# Access Compliance Report

## Public Rights-of-Way

| Intersection ID: 3221                   | Main Street: FAIRBOURNE_CT | Cross Street: HIGHCROFT_LN              | Location: NW           |
| ADA ID: 4D8F46549BF3                    | Ramp Type: Perp            | Initial Pass/Fail: Fail                 | Overall Compliance: No |

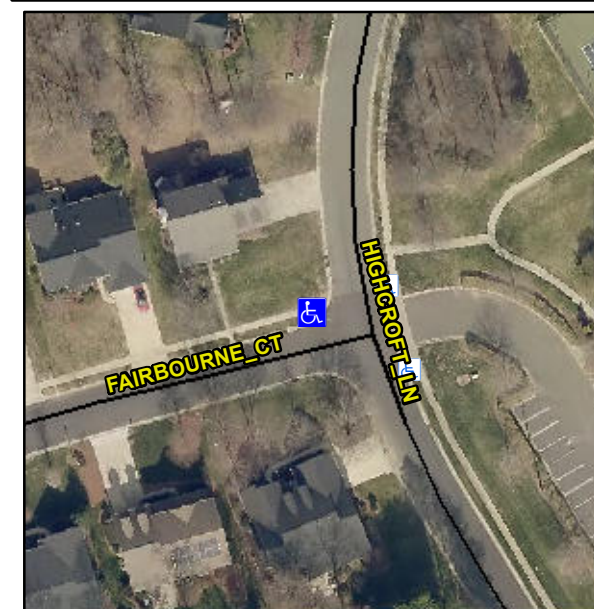
**Not Found, R304.2.2, R304.5.3**

| Compliance | Description           | Data | Compliance | Description                 | Data |
|------------|-----------------------|------|------------|-----------------------------|------|
| N/A        | Ramp Length (in)      | 45.0 | No         | Ramp Slope (%)              | 8.6  |
| Yes        | Ramp Width (in)       | 90.0 | No         | Ramp XSlope (%)             | 3.7  |

**Remove & Replace Entire Ramp.**
